APPENDIX C
CODE CHANGE PROPOSAL
NORTH CAROLINA
BUILDING CODE COUNCIL

North Carolina State Building Code, Volume RESIDENTIAL Section AM105.1

Code Change to NC Residential Code Section AM105.1 – Version 3 3-13-18

Code Change to NC Residential Code Section R4603.6 Version 3

**FIGURE R4603.6(b)
TOP MOUNTED GIRDER**

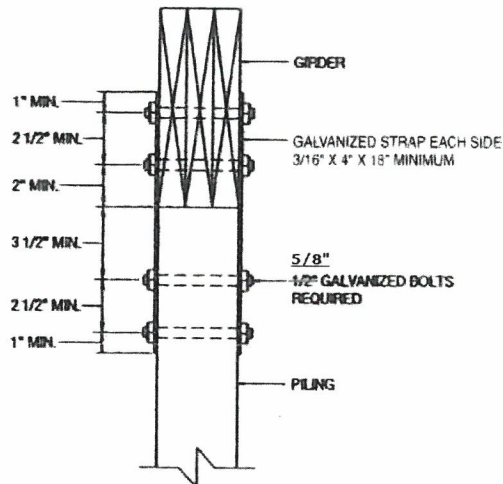
Beams and girders shall fully bear on pilings and butt joints shall occur over pilings. If Sills, beams or girders are shall be attached to the piling a minimum of two 5/8 inch (16 mm) galvanized steel bolts per beam member shall be through bolted using either bolts or screws at each piling connection in accordance with Table R4603.6 and Figure R45603.6 (a). When the piling is notched so that the cross-section is reduced below 50 percent or the girder is top bearing, sills, beams or girders shall be attached using 3/16 × 4 × 18-inch (5 × 102 × 467 mm) hot dip galvanized straps, one each side, bolted with two 5/8 inch (15.9 mm) galvanized through bolts fastened top and bottom in accordance with either bolts or screws in accordance with Table R4603.6 and Figure R4603.6(b) and Figure R45603.6(c). Where butt joints occur over the piling and screws are used, there shall be two straps on each side of the piling, having a minimum size of 3/16 by 2 by 18 inches (5 × 51 × 467 mm), with four self-drilling screws as described in each end.

Revise Figures as follows:

**FIGURE R4603.6(c)
PILING NOTCHED MORE THAN 50%**

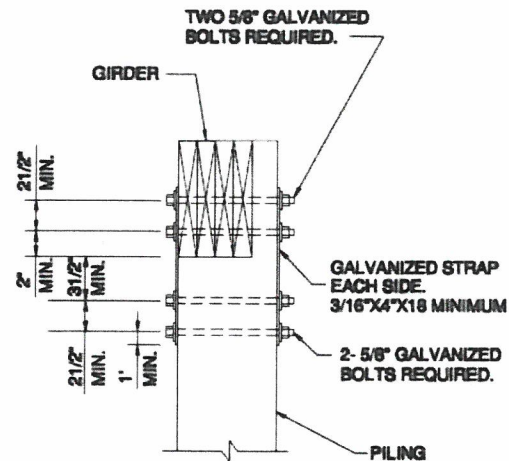
1. Where piling is notched over 50%, use strap as required in Section 4603.6. Install the specified number of bolts or screws in each end of the strap.
2. Bolts shall be 5/8" diameter hot dipped galvanized through bolts with nuts and washers.
3. Screws shall be 0.270" (6.9 mm) minimum in diameter, hot dipped galvanized to a minimum of A153, Class C, and having a minimum length of 4", and also shall be long enough to penetrate at least one inch through the remaining pile and into the girder.

Figure 410.2 Exception Closet Storage Space Exception

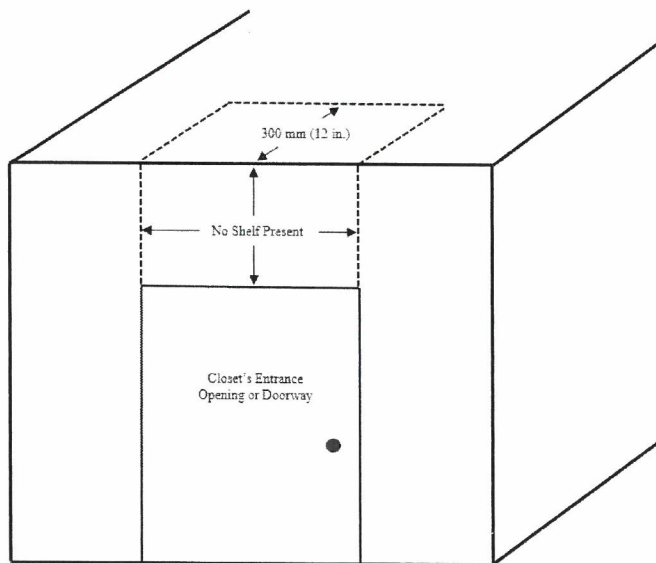
Where a shelf is not present in the area of wall above the closet's entrance opening or doorway extending from the top of such opening or doorway vertically to the ceiling, including the area of ceiling extending perpendicular from the area of wall directly above the closet's entrance opening or doorway to a horizontal distance of 300 mm (12 in.) shall not be defined as closet storage space. See Figure 410.2 Exception.
